Response to Reviewer 1

Response to Reviewer 2

110 **Response to Reviewer 3**

Response to Rémi Gandoïn

20 Figure R1.1: As in Fig. 11 in the manuscript, but using NMAE. The features generally match those in Fig. 11.

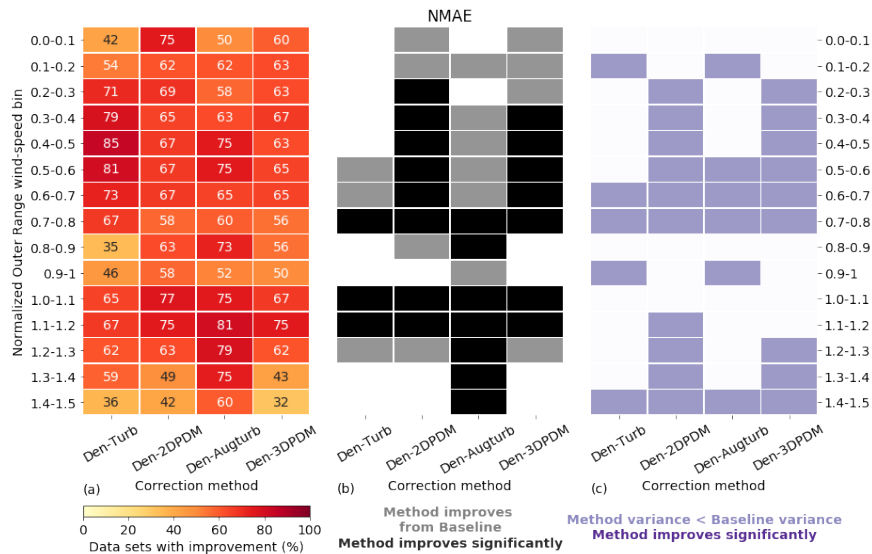
1. The reviewer commented the use of NME in the manuscript. We understand that NME averages out positive and negative errors. The reviewer made a valid point that using NME does not reflect the error of power production from each 10-minute period. Meanwhile, the focus of this study is to evaluate the correction capabilities on the overall bias of each trial method over long periods, hence we choose to use NME instead of NMAE. We want to investigate whether a correction method generally overpredicts or underpredicts production in different meteorological conditions, and NME is valid for such purpose. Moreover, because the metadata and the data sample size vary in the collected submissions, we primarily discuss the average bias in this study, as a foundation for future analyses.

NMAE is useful to evaluate the prediction error in specific, short-term events, while the metric does not provide information on the direction of bias. In this study, our focus is on average bias rather than the cumulative error of a correction method. In fact, the statistical results from NMAE are analogous to those of NME, please see the plot below. As the reviewer suggested, we will assess NMAEs in future study, when we have large sample size and higher quality data.

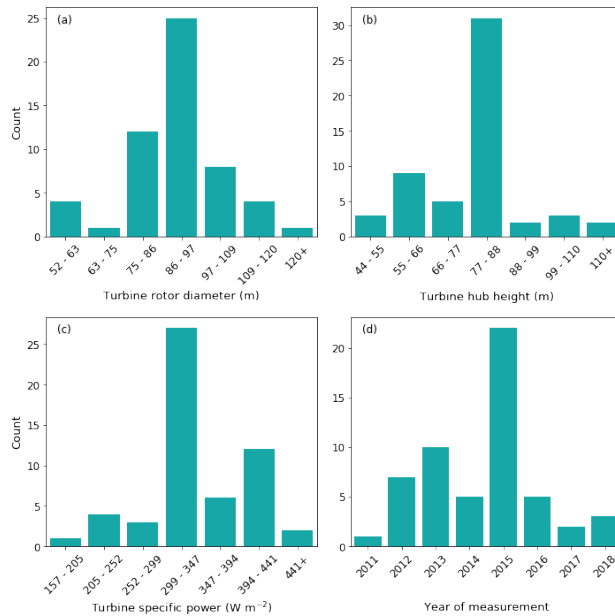
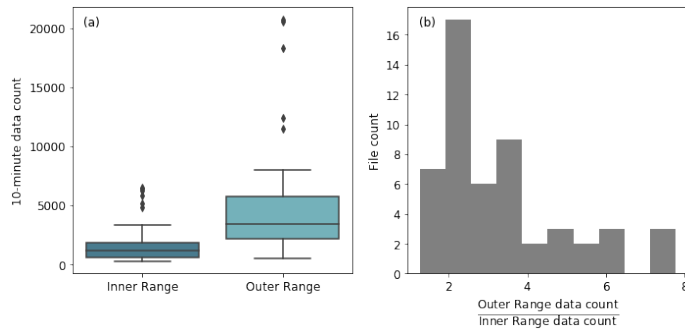
Line 231 to 239: Do you provide statistics about how much data is found in each category, for instance: for more than 80% of
445 the tests, less than 30% of the data are in the inner range... or something like this, which could help visualise the populations
?

Response: Sect. 4.1, including Fig. 4 and Fig. 5, is dedicated to discussing the metadata distributions.

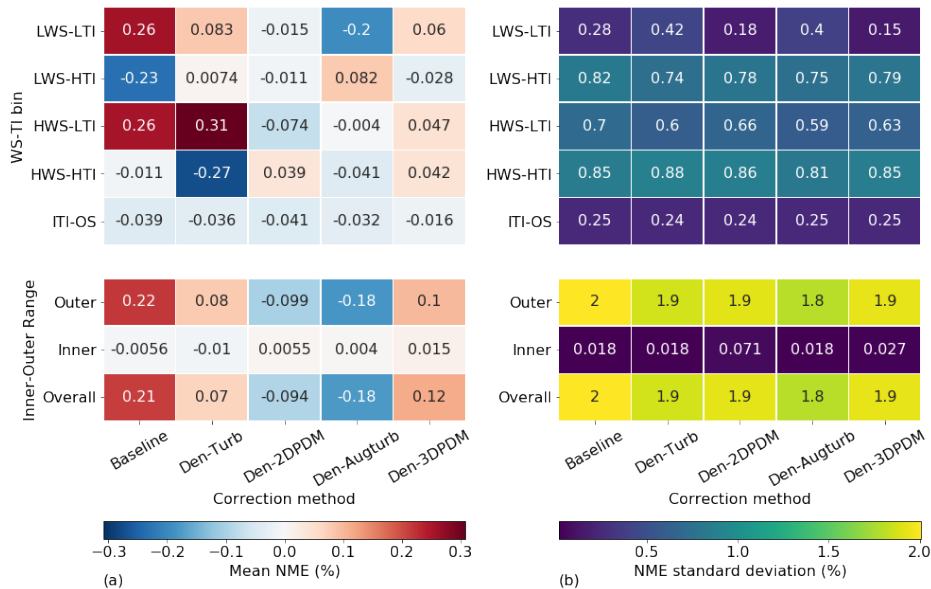
Line 346: can you explain where these results are in Figure 8a (row, column) ?

485 Response: This is explaining the “ITI-OS”, which is Inner Range TI and Outer Range shear, and it is the 5th row from the top.
